Groundwater Application Review Summary Form

Application # G- 18843

GW Reviewer Karl Wozniak Date Review Completed: 04/03/2020

TO: Water Rights Section Date April 3, 2020
 FROM: Groundwater Section Karl Wozniak and Ben Scandella
Reviewer's Name
 SUBJECT: Application G- 18843 Supersedes review of _____
Date of Review(s)

Well Statistics: Sections 31 & 32, 2S/2W

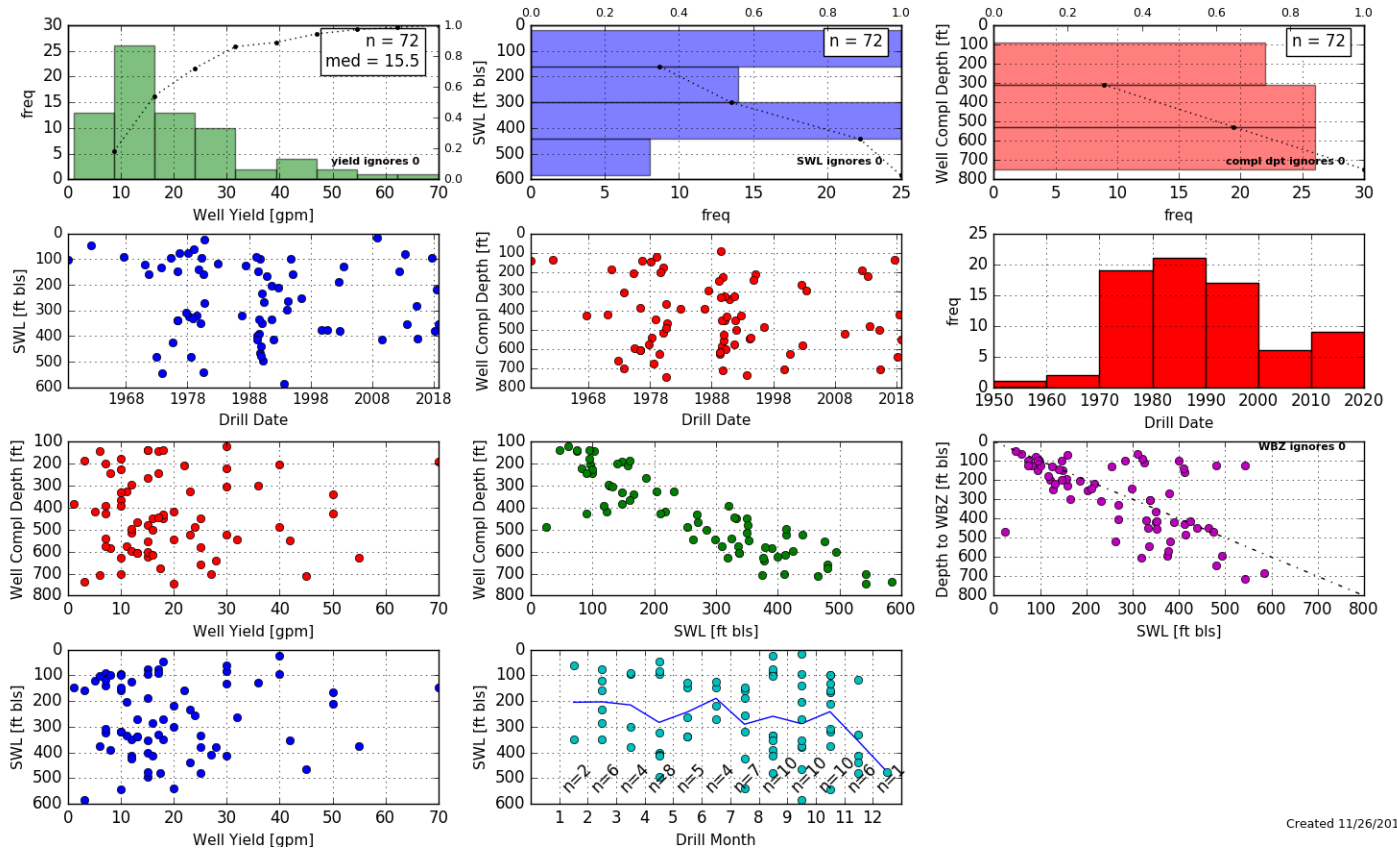
Although representative observation wells are not available in the area, well deepenings are rare, and static water levels reported on well logs show no obvious trend over time (see enclosed well statistics plot). These facts indicate that groundwater levels are probably stable at the present time. The recommended water-level decline and shut-off conditions should protect the resource from any potential injury from the proposed use.

Well Location Map

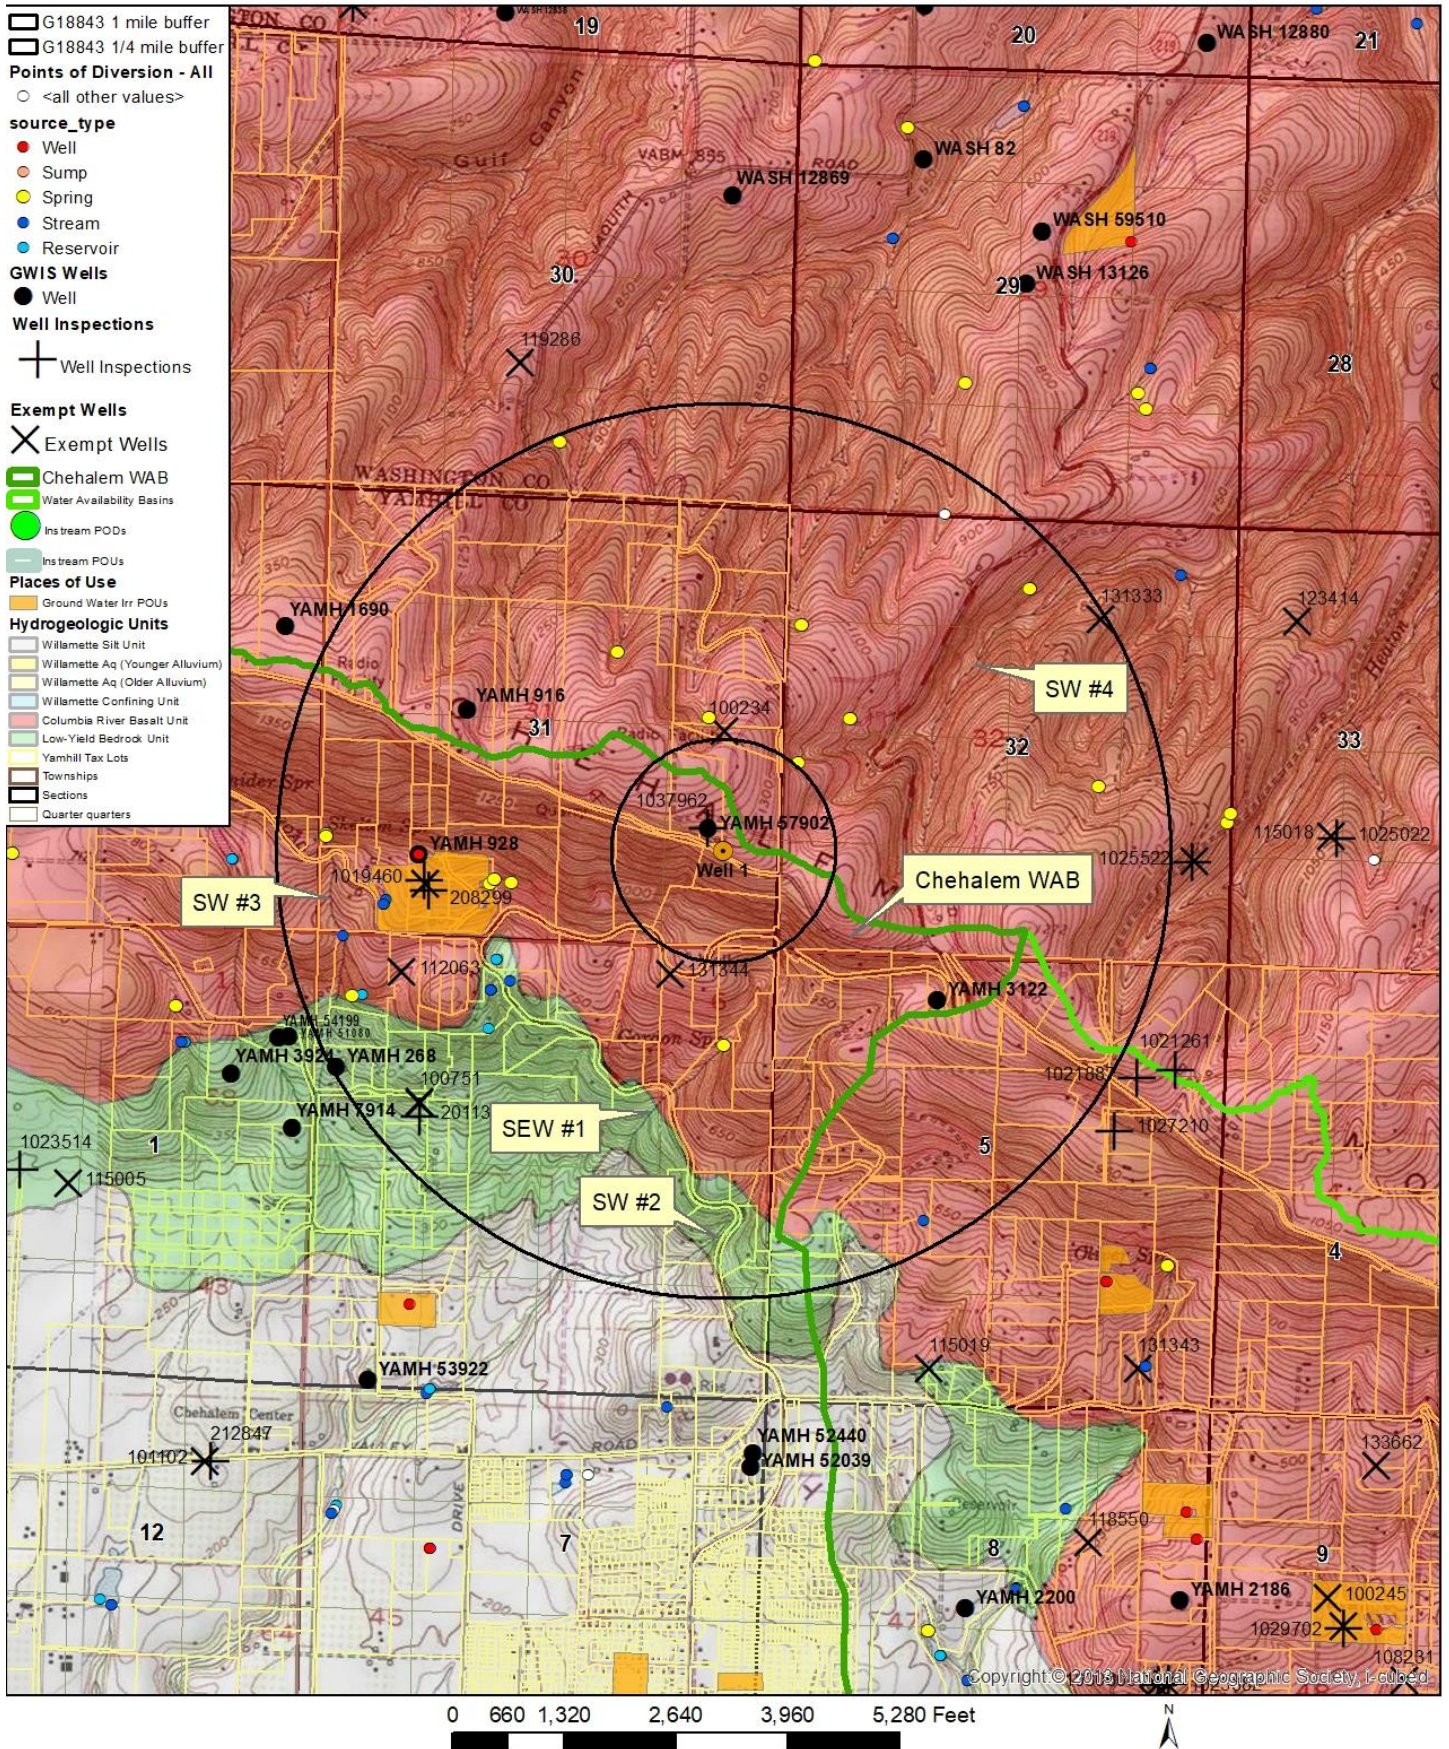
Water well density is quite low in the surrounding area. Only one basalt irrigation well (at about 3600 feet to the west) occurs within a 1-mile radius of the proposed well. Tax lot maps and the OWRD well log database indicate that at least 50 domestic basalt wells lie within a 1-mile radius but these are not likely to all be completed in the same aquifer because of the layering in the basalt aquifer system, the great topographic relief, and highly variable well depths. Potential impacts to existing wells from the proposed well are difficult to assess because of a lack of knowledge about local hydraulic properties and the geometry of individual aquifers. Nevertheless, the low proposed (or allowed) production rate probably precludes substantial interference with most of the surrounding wells except those that are in close proximity and completed in the same water-bearing zones. The closest known well is YAMH 57902, about 300 feet to the northwest, but the well log indicates a water column of about 260 feet which should be sufficient to buffer any interference from the proposed well. Protections for potential impacts to existing wells should be adequately addressed by the recommended water-level and water-use conditions listed in section B1di above, which are required in the basalt aquifer system by basin rules in OAR 690-502-0250.
